SUBJECT: Forwards proprietary & non-proprietary response to NRC 990317
 RAI re TR DPC-NE-3005-P, which describes new Duke methodology
 for analyzing Oconee UFSAP Chapter 15 non-LOCA transients &
 accidents. Proprietary info withheld, per 10CFR2.790.

Subject: Oconee Nuclear Station
Docket Numbers 50-269, -270, -287
UFSAR Chapter 15 Transient Analysis Methodology,
Topical Report DPC-NE-3005-P, Revision 1

Responses to Request For Additional Information
DPC-NE-3005P Revision 1

Figure 1

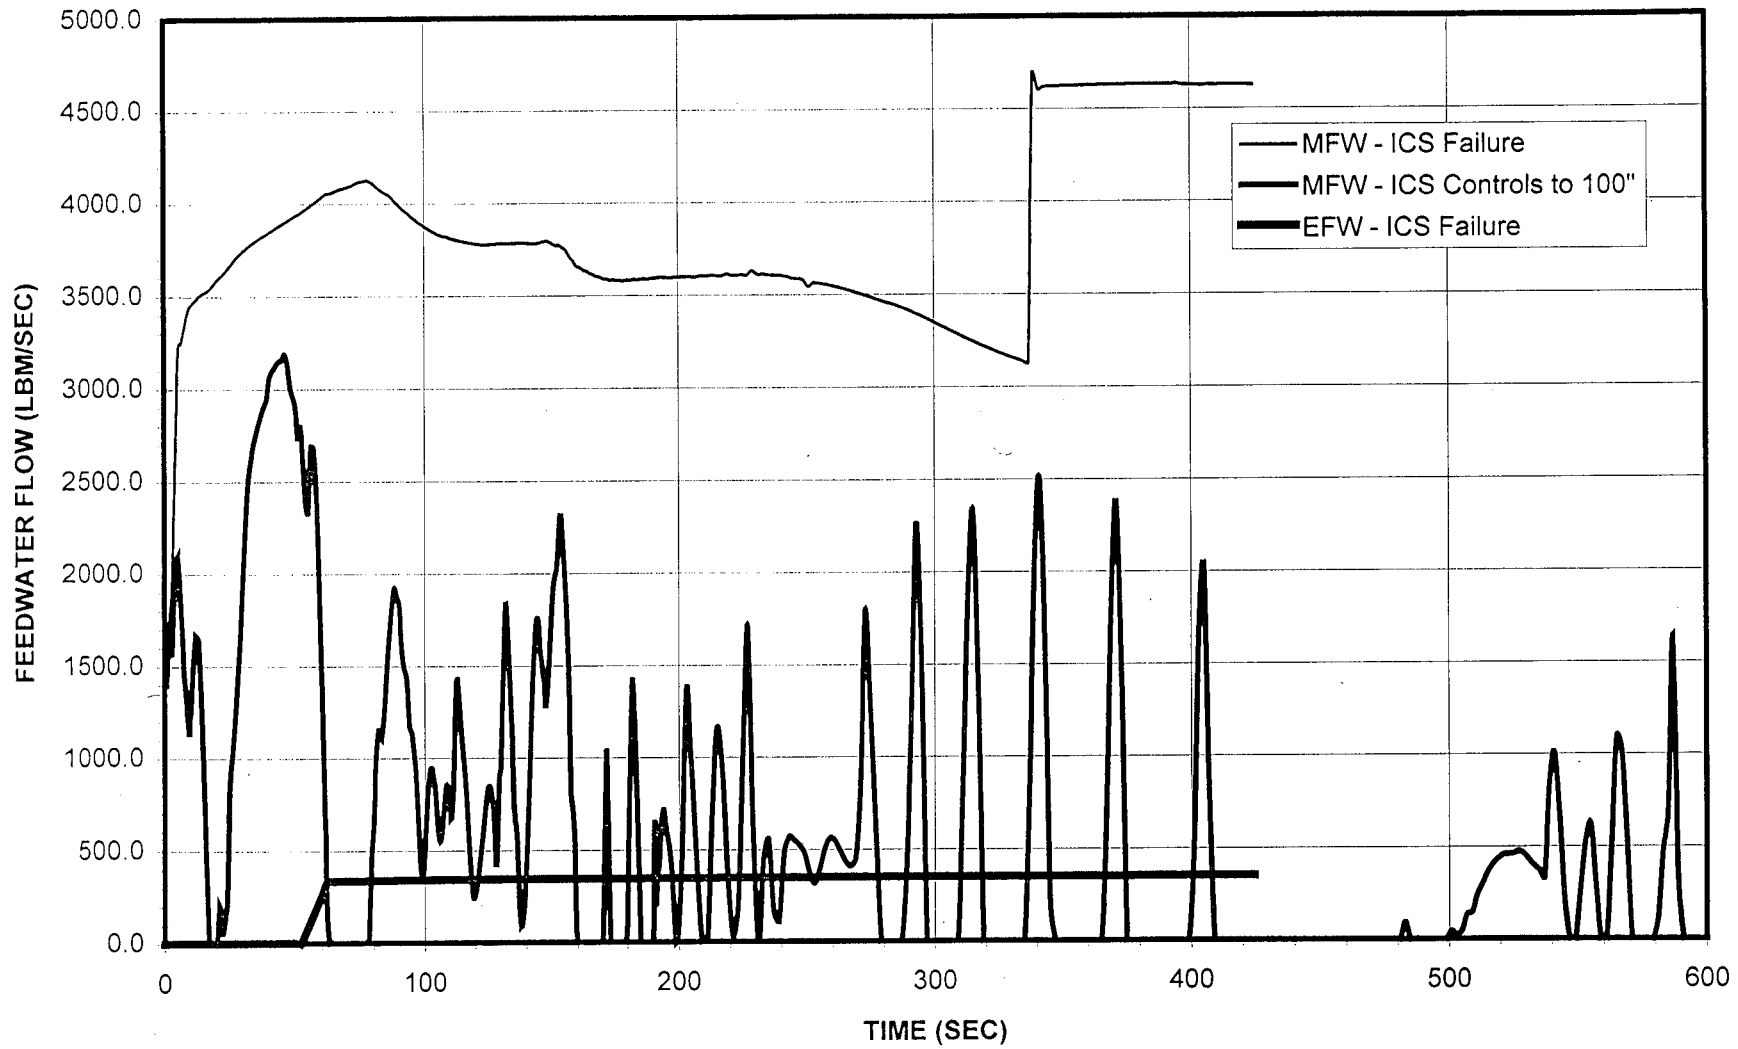
- Q6. Page 15-14 states that the limiting assumption with respect to maximizing overcooling and reactivity addition has been determined by analysis to be the case when the Integrated Control System (ICS) is controlling main feedwater. This case was found to cause more overcooling than the case that assumes failure of the ICS, which would permit unlimited main feedwater addition to the affected steam generator. Provide comparisons of the conditions within the affected steam generator secondary that would cause the ICS operating case to be the worst case. Compare steam generator level, pressure, temperature, and heat transfer coefficients that are calculated by the RETRAN code.

Figure 1 shows the feedwater flowrates to the affected steam generator. With the ICS controlling level to 100 inches, the MFW flow is throttled, whereas for the ICS failed both MFW and EFW flowrates are uncontrolled and much higher. Figure 2 shows the resulting steam generator level. With level control the level is approximately controlled to 100 inches, although the dynamic behavior of the transient causes instability in feedwater control and level response. Without level control the level continues to fill until going offscale at approximately 250 seconds. Figure 3 shows the steam generator liquid mass. With ICS level control the liquid mass is limited to 20,000-50,000 lbm, whereas the overfilled condition without ICS control reaches 180,000 lbm. The significant difference in the feedwater flow boundary condition for the two cases is evident.
